MEMORANDUM

**To:** Montgomery Township Zoning Board of Adjustment  
**From:** Michael Sullivan, ASLA, AICP  
Melissa McMullen, AICP  
**Re:** **Golden Bison Investments, LLC**  
**Building Coverage Variance**  
59 Zion-Wertsville Road  
Block 11002, Lots 14 and 15  
MR Mountain Residential Zone  
**Date:** January 3, 2023

## GOLDEN BISON INVESTMENTS, LLC | BUILDING COVERAGE VARIANCE

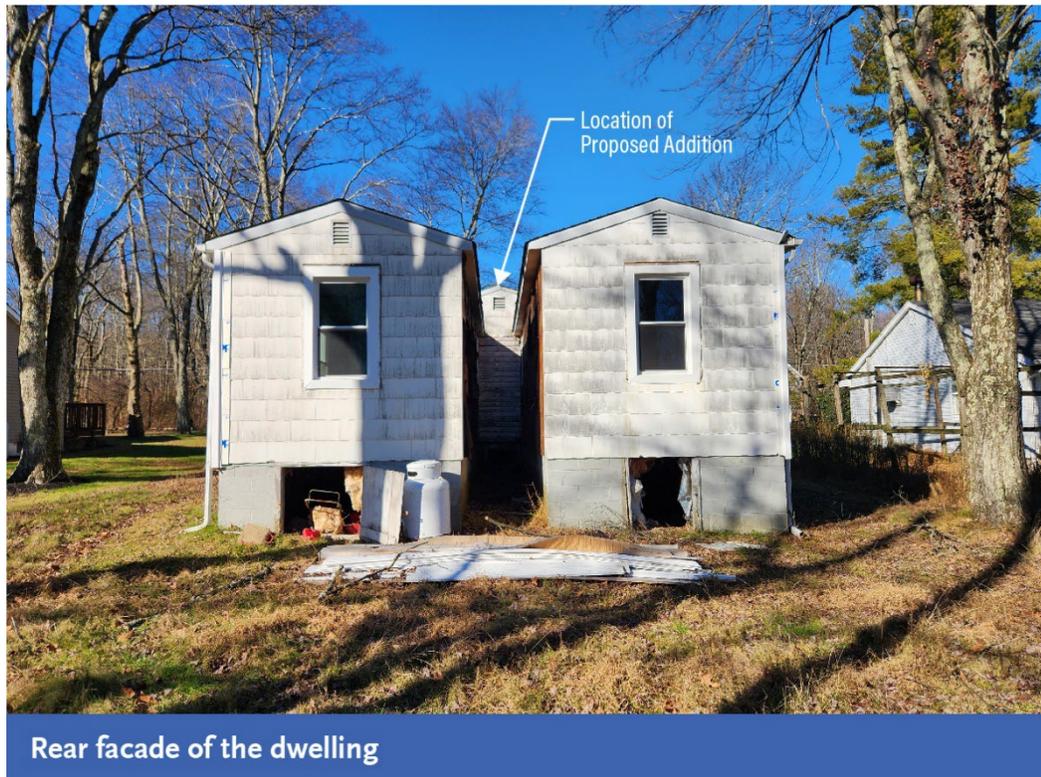
- 2.4 **Area & Yard Requirements. Variance relief is necessary.** The application does not meet the maximum building coverage required per 16-4.2d. The proposed 112 addition to the dwelling increases the property’s building coverage from 7% to 7.7%, requiring variance relief. Additionally, the proposed R.O.W. dedication reduces the lot area to 0.457 ac where 10 ac is required and the front yard to 59.7 ft where 100 ft is required. Each of these items require variance relief. See Table 1 for additional details on the applicant’s compliance with the area and yard requirements. The following analysis is based on looking at the two lots as a single consolidated lot.

- 2.5. **Area & Yard Requirements.** In accordance with §16-6.2, properties made undersized due to voluntary R.O.W. dedication shall not be penalized regarding

building coverage and other provisions of the Land Development Chapter. The proposed ROW dedication does not “*make*” the property undersized, but makes the property “*further*” undersized, as the property currently does not meet the ordinance standards. Therefore, variance relief may be required.
